REQUEST FOR DRAWING CHANGE APPROVAL

It is respectfully requested that the Examiner approve the following proposed changes to Figs. 4, 8-10, 15, 17 and 22B of the drawings of the above-identified application:

Fig.4

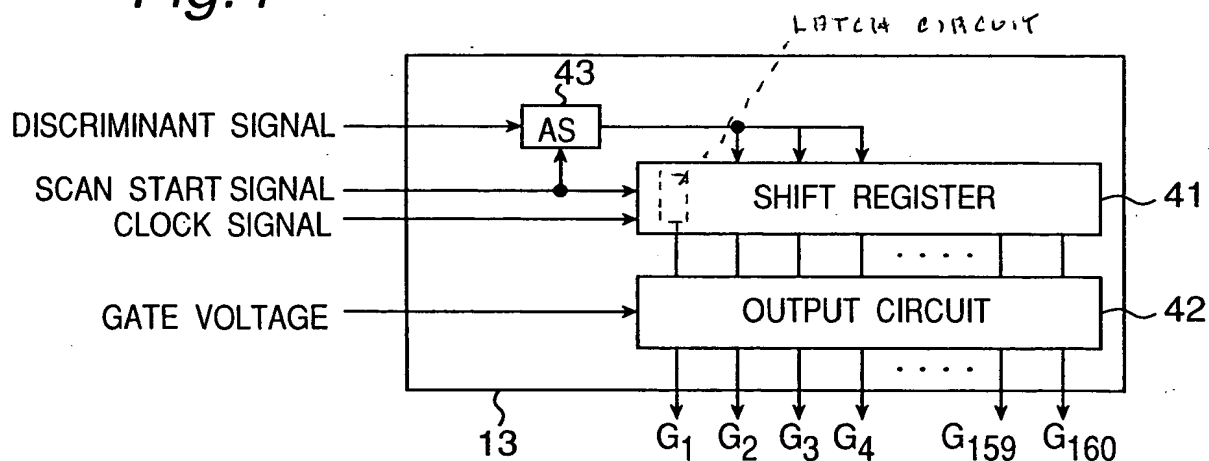
Please add a dotted outline box within the block designated as "Shift Register", a dotted lead line extending therefrom, and the words "Latch Circuit" at the outer end of the dotted lead line, as shown in red on the attached photocopy of Fig. 4.

Fig.8 PRIOR ART

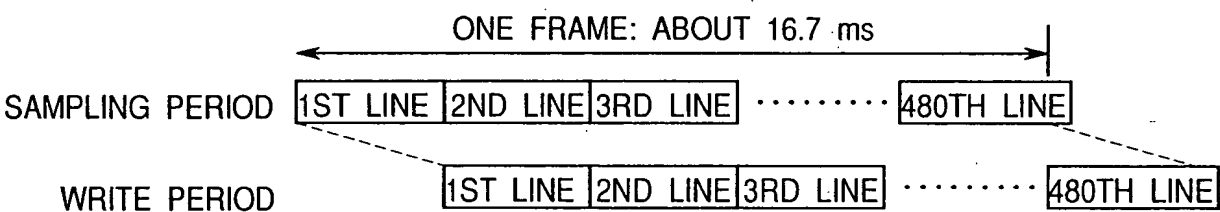
Also, please add the legend "PRIOR ART" to Figs. 8-10, 15, 17 and 22B, as shown in red on the attached photocopies of Figs. 8-10, 15, 17 and 22 of the drawings originally filed with this application, respectively.
